MFN 10-044 Supplement 1

Subject: Response to NRC Request for Additional Information Letter No. 411 Related to ESBWR Design Certification Application – Engineered Safety Features – RAI Number 6.2-202 Supplement 1

**Response to NRC Request for
Additional Information Letter No. 411
Related to ESBWR Design Certification Application**

RAI Number 6.2-202 S01

Figure 6.2-202 S0.3. ESBWR Post-LOCA Radiolytic Gas Production of Hydrogen and Oxygen in RPV

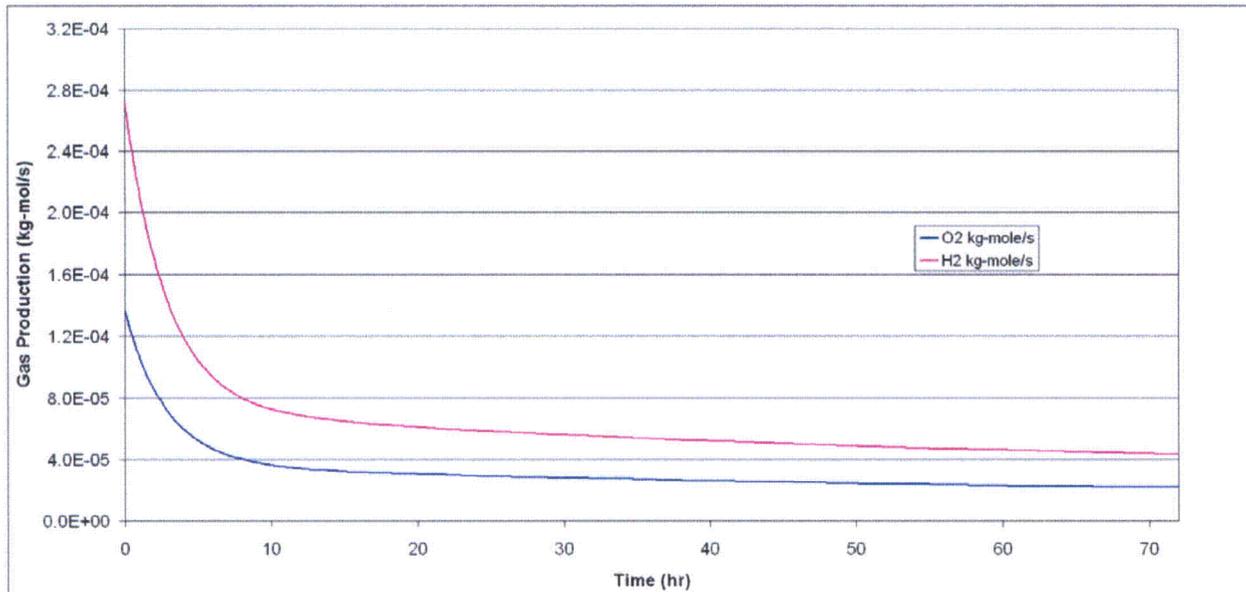
The refilling time of the PCCS is based on conservatively assuming radiolytic gases are only available to fill the PCCS. Figure 6.2-202 S0.3 shows radiolytic production of hydrogen and oxygen for ESBWR post-LOCA.

Figure 2.4.1-1. Isolation Condenser System Schematic

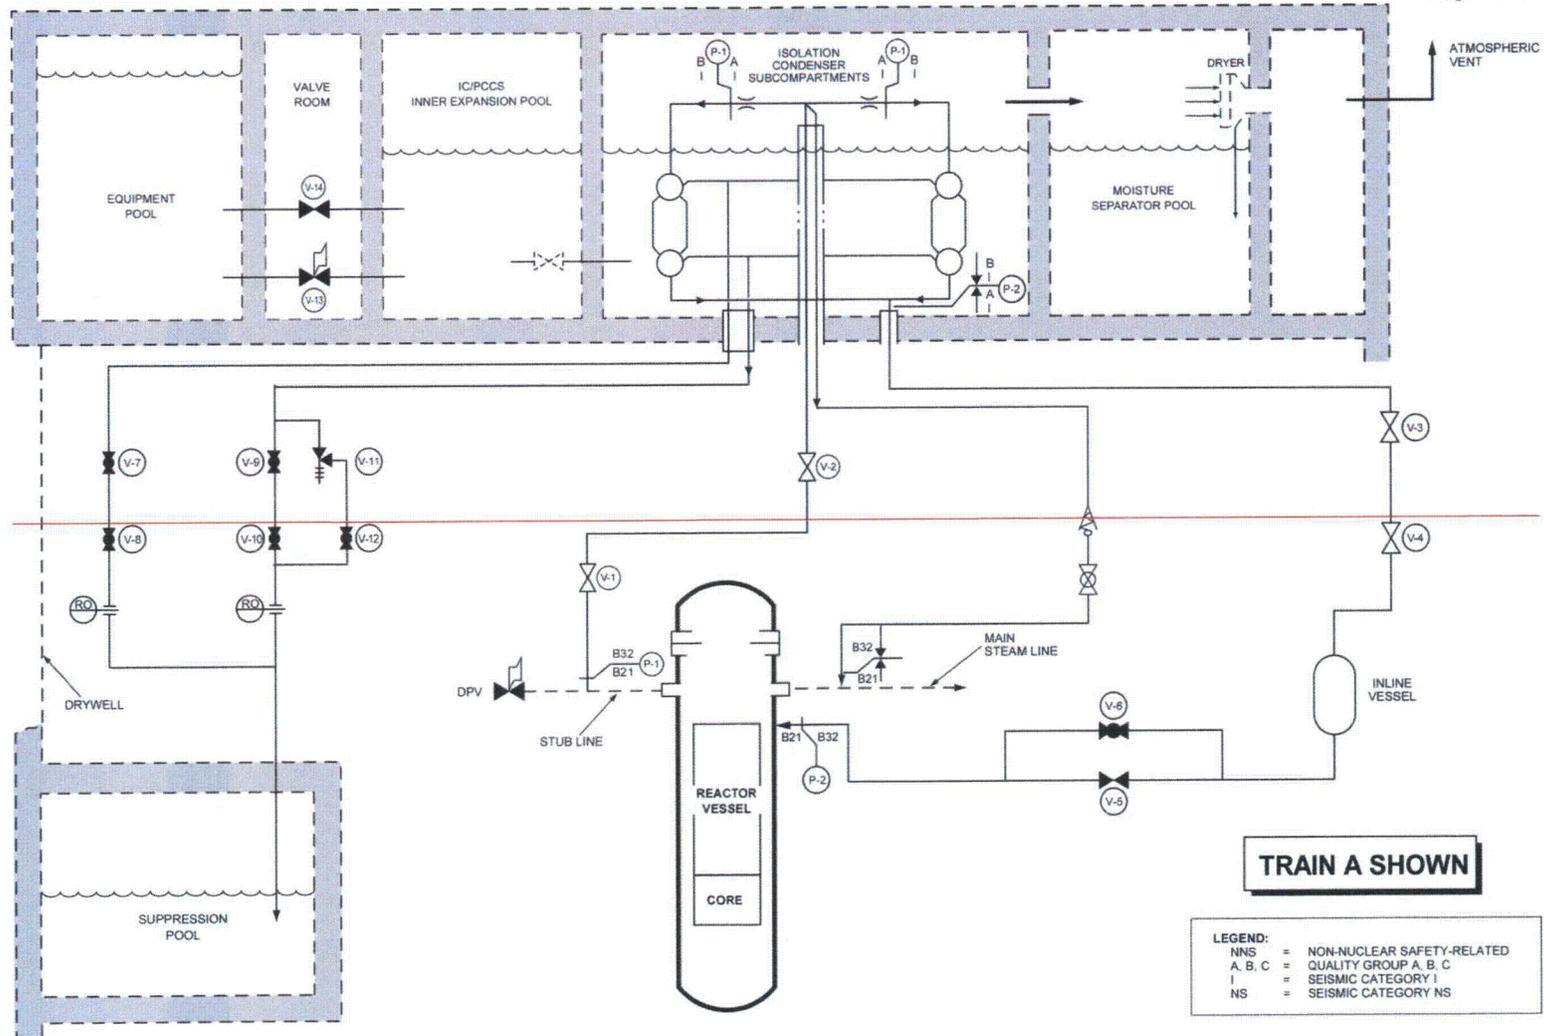
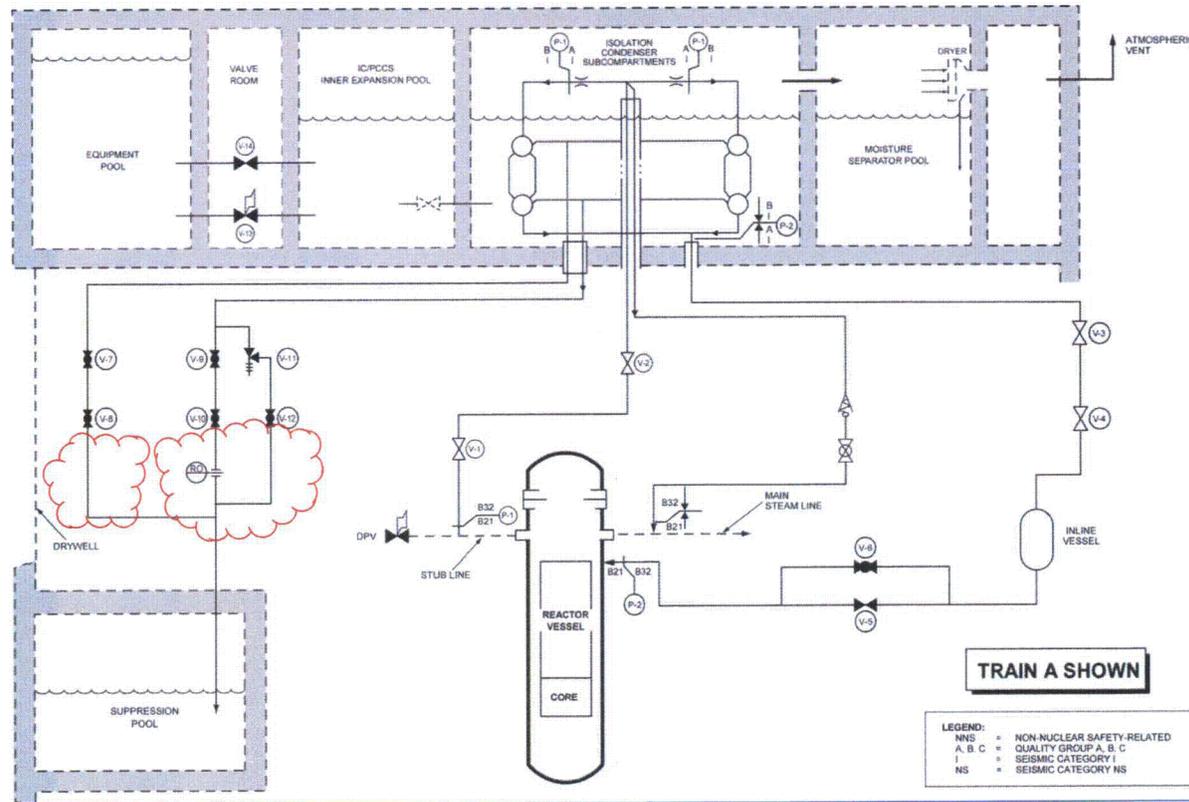
Equipment Name (Description)	Equipment Identifier See Figure 2.4.1-1	ASME Code Section III	Seismic Cat. I	RCPB Component	Containment Isolation Valve	Remotely Operated	Loss of Motive Power Position
IC (B) Condensate Return Line Bypass Valve	V-6(B)	Yes	Yes	Yes	No	Yes	Open
Upper IC (B) Header Vent Line	--	Yes	Yes	No	--	--	--
Upper IC (B) Header Vent Line Valve	V-7(B)	Yes	Yes	No	Yes	Yes	Closed
Upper IC (B) Header Vent Line Valve	V-8(B)	Yes	Yes	No	Yes	Yes	Closed
Lower IC (B) Header Vent Line	--	Yes	Yes	No	--	--	--
Lower IC (B) Header Vent Line Valve	V-9(B)	Yes	Yes	No	Yes	Yes	Closed Open
Lower IC (B) Header Vent Line Valve	V-10(B)	Yes	Yes	No	Yes	Yes	Closed Open
Lower IC (B) Header Vent Line Valve	V-11(B)	Yes	Yes	No	Yes	No	NA
Lower IC (B) Header Vent Line Valve	V-12(B)	Yes	Yes	No	Yes	Yes	Open
Lower IC (B) Header Vent Line Restricting Orifice of 0.167 cm ² (0.0259 in ²) flow area.	RO(B)	Yes	Yes	No	No	No	--

Figure 2.15.4-1. Passive Containment Cooling System Schematic

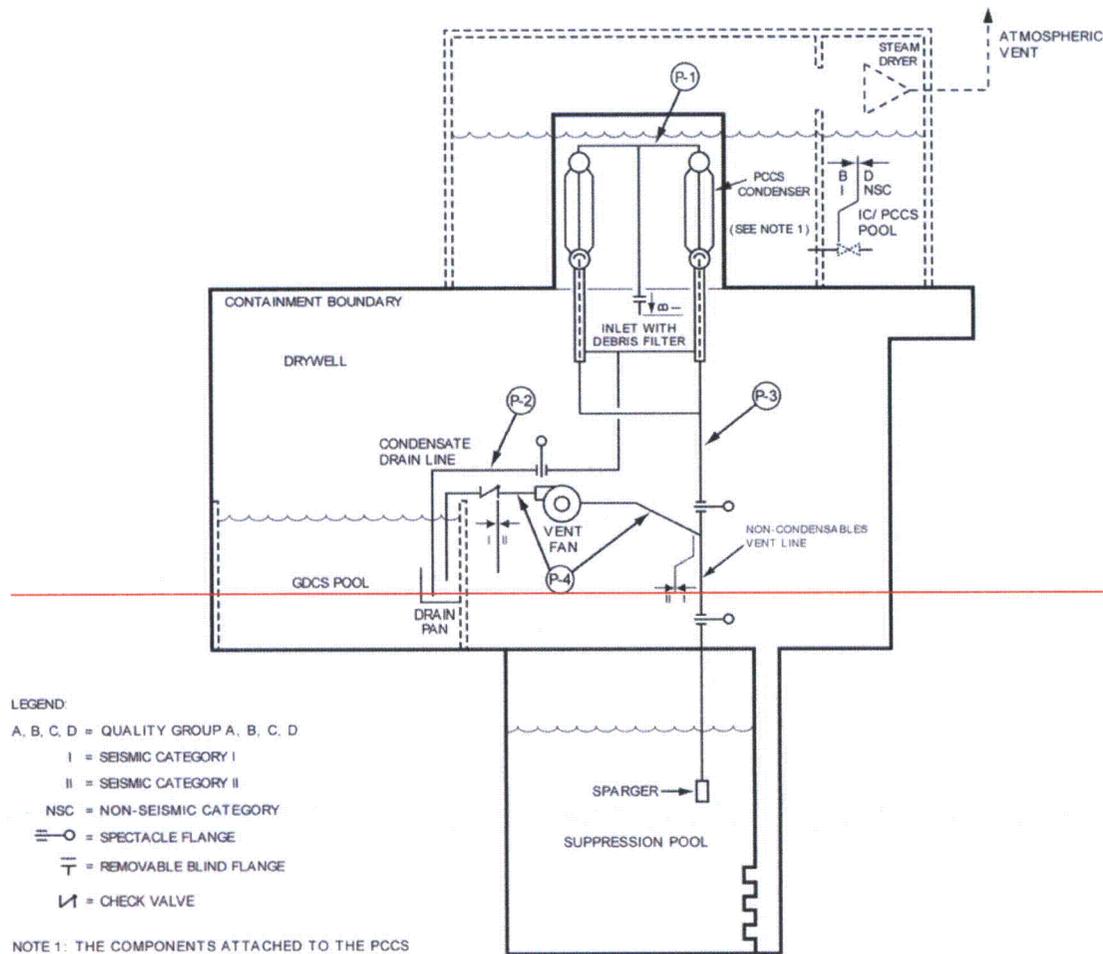
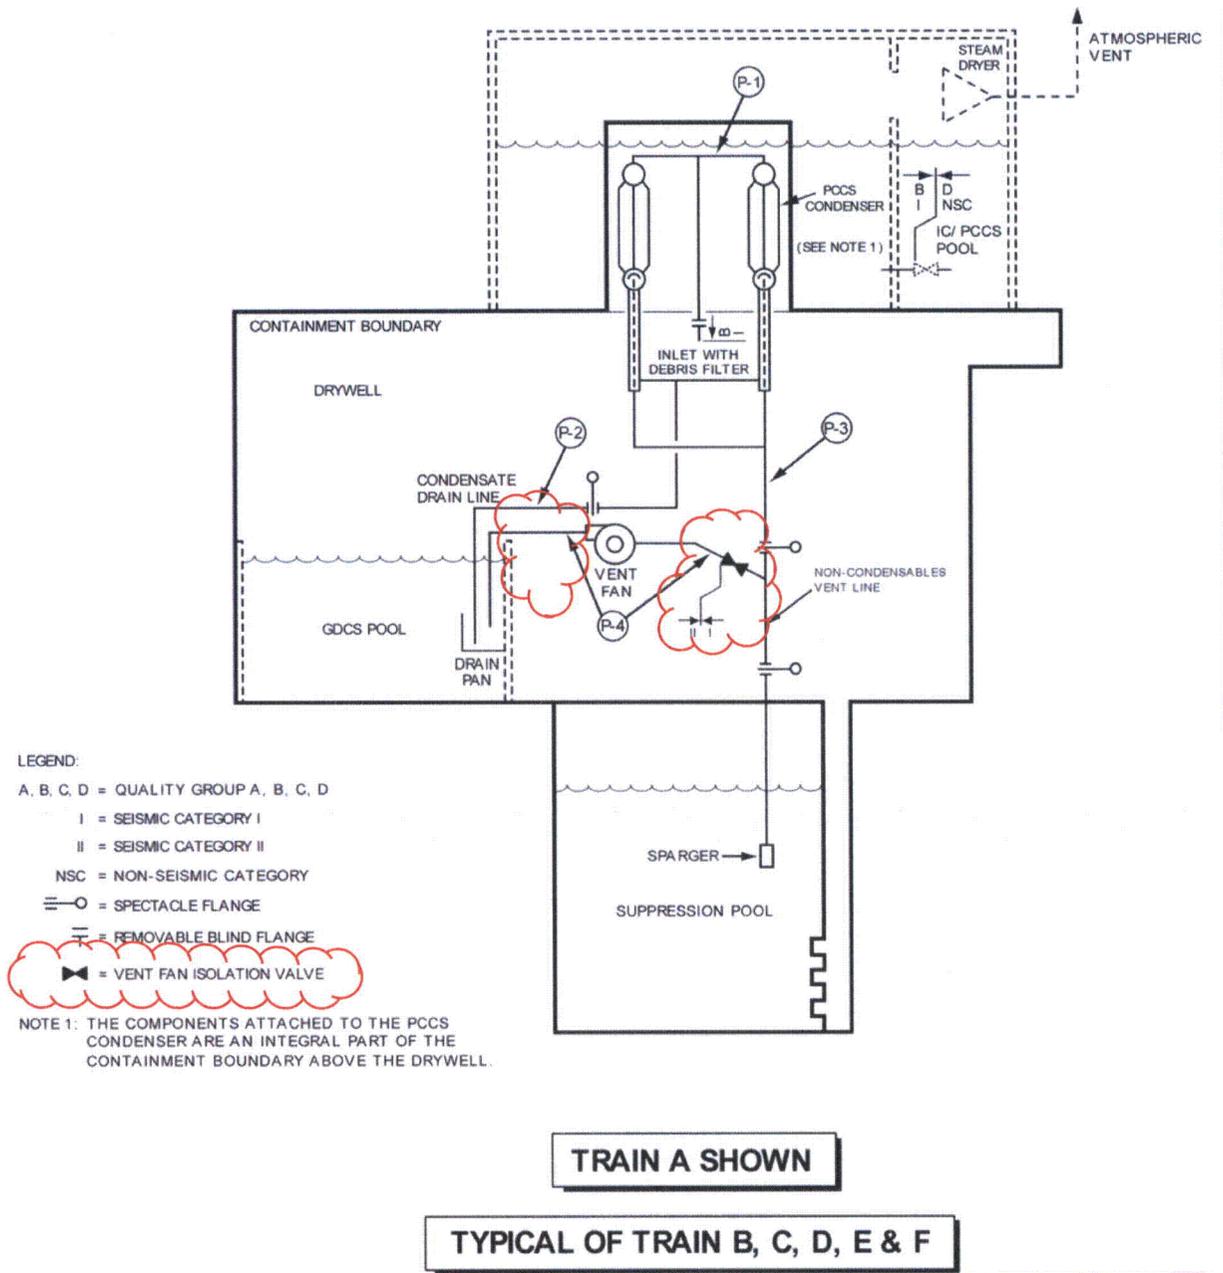
Equipment Name (Description)	Equipment Identifier see Figure 2.15.4-1	ASME Code Section III	Seismic Cat. I	RCPB Component	Containment Isolation Valve	Remotely Operated Valve	Loss of Motive Power Position
<u>PCCS Vent Fan Catalyst Module</u>	=	<u>No</u>	<u>Yes</u>	<u>No</u>	=	=	=

Design Commitment	Inspections, Tests, Analyses	Acceptance Criteria
<p>16. <u>To reduce hydrogen accumulation in the PCCS vent lines, vent line catalyst modules recombine hydrogen at a required minimum rate at a minimum allowed velocity.</u></p>	<p><u>Type tests will be performed to verify a minimum required hydrogen recombination rate at a minimum allowed velocity.</u></p>	<p><u>Type tests show that the as-built catalyst module will recombine hydrogen at a minimum rate of 1.66 kg/h (3.66 lbm/h) when exposed to a test stream consisting of 4% hydrogen in its stoichiometric ratio with oxygen, the balance being inert gas, and whose minimum velocity through the module is 0.166 m/s (0.545 ft/s).</u></p>

Figure 5.1-3. Isolation Condenser System Schematic

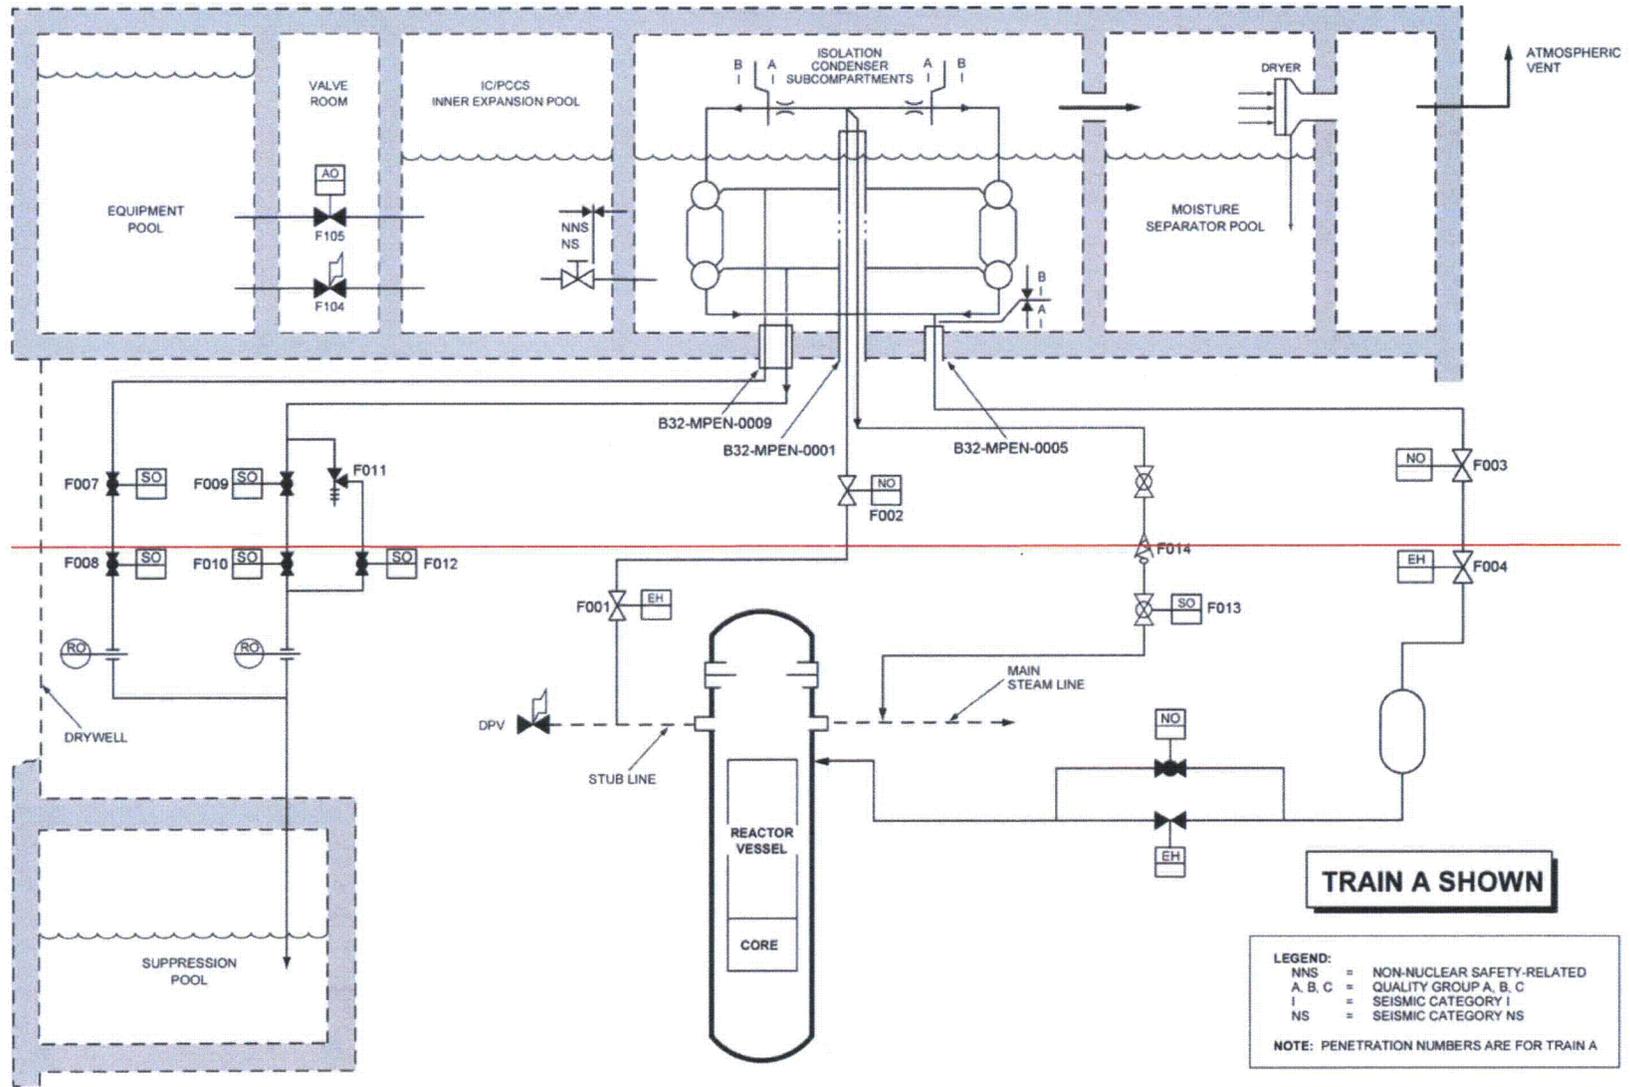
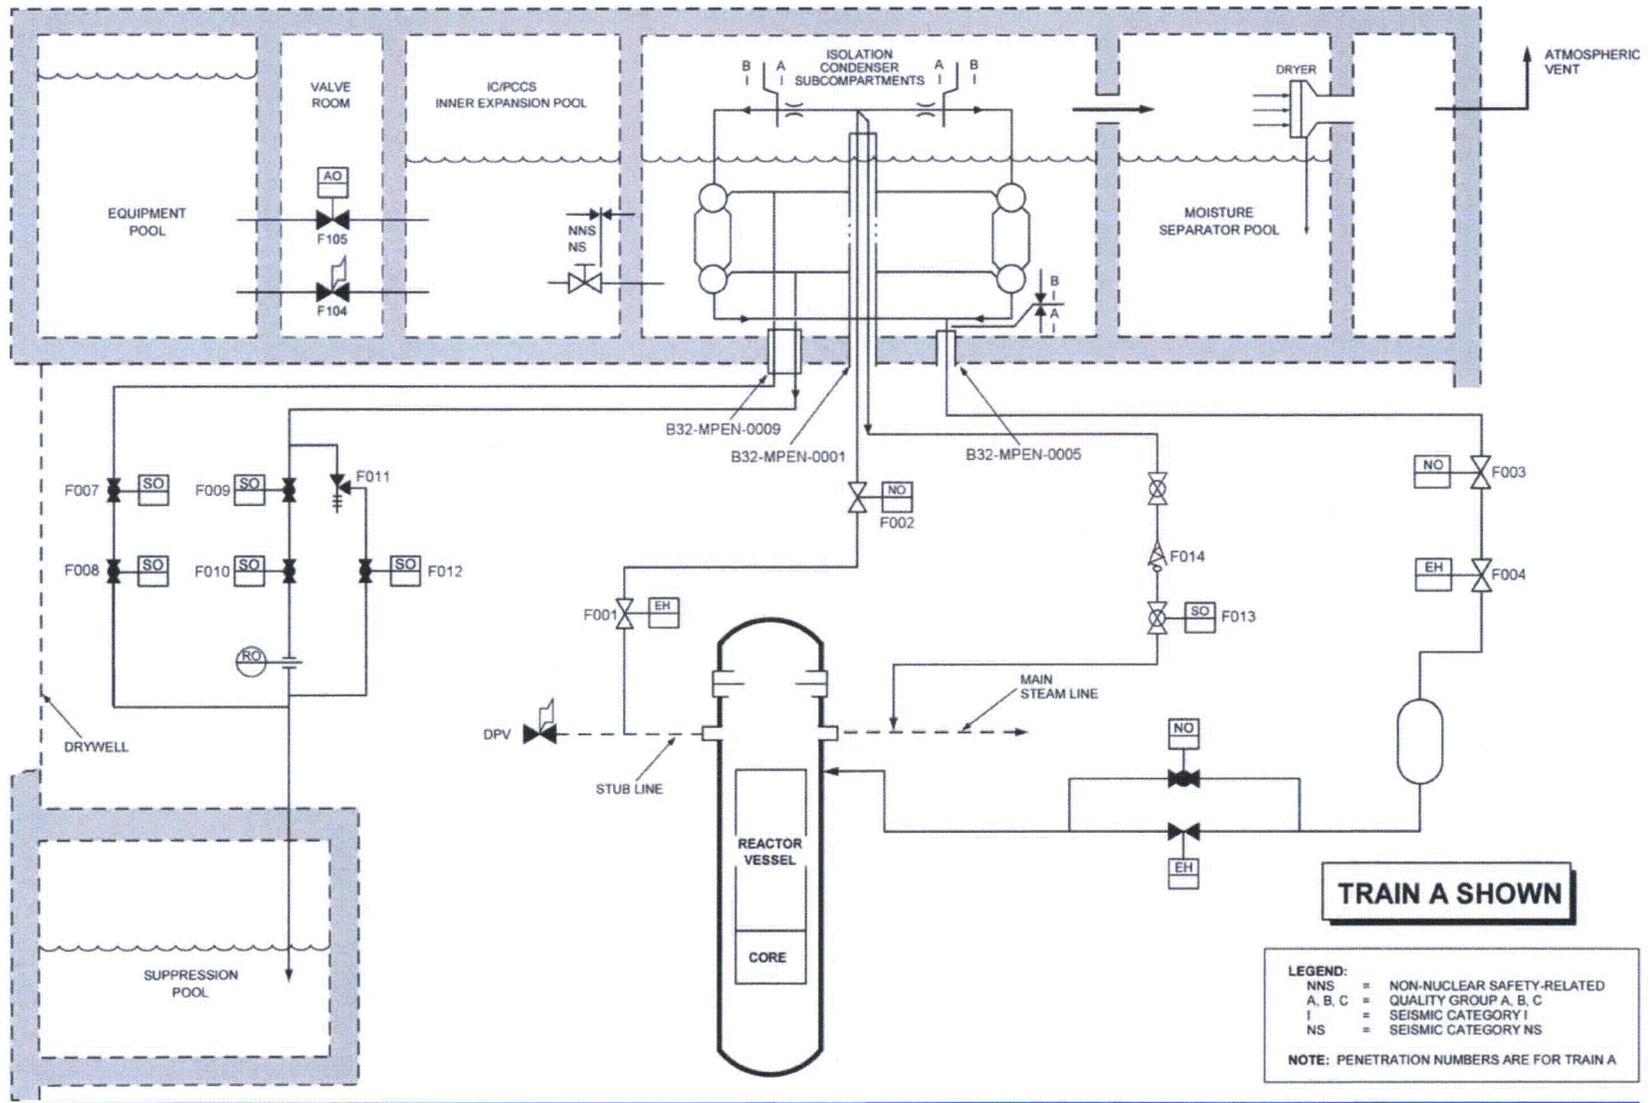
The vent line is equipped with a flow restricting orifice of flow area 0.167 cm^2 to reduce the loss of RPV inventory. It is located down stream of valve F010, See markups for DCD Tier 2, Figure 5.1-3. Revised water levels for Station Blackout are reported in DCD Tier 2, Subsection 15.5.5.3 and Table 15.5-10b, which show that level is still maintained above Level 1. These results are based on an orifice flow area of 0.667 cm^2 , which provides conservative results for RPV inventory losses.

The automated venting function during non-LOCA events is accomplished through the existing vent line on the lower header of the ICS. Vent valves F009 and F010 are opened and restricting flow orifice is placed downstream of valve F010. See markups of DCD Tier 2, Figure 5.1-3.

- A vent line is provided for both upper and lower headers to remove the noncondensable gases away from the unit, during isolation condenser operation. The vent lines are routed to the containment through a single penetration. The lower header vent line in the drywell is composed of the main vent line and bypass line. The main vent line has a 0.167 cm^2 (0.0259 in^2) restricting orifice located downstream of valve F010 (see Figure 5.1-3) which limits RPV inventory loss during its operation.
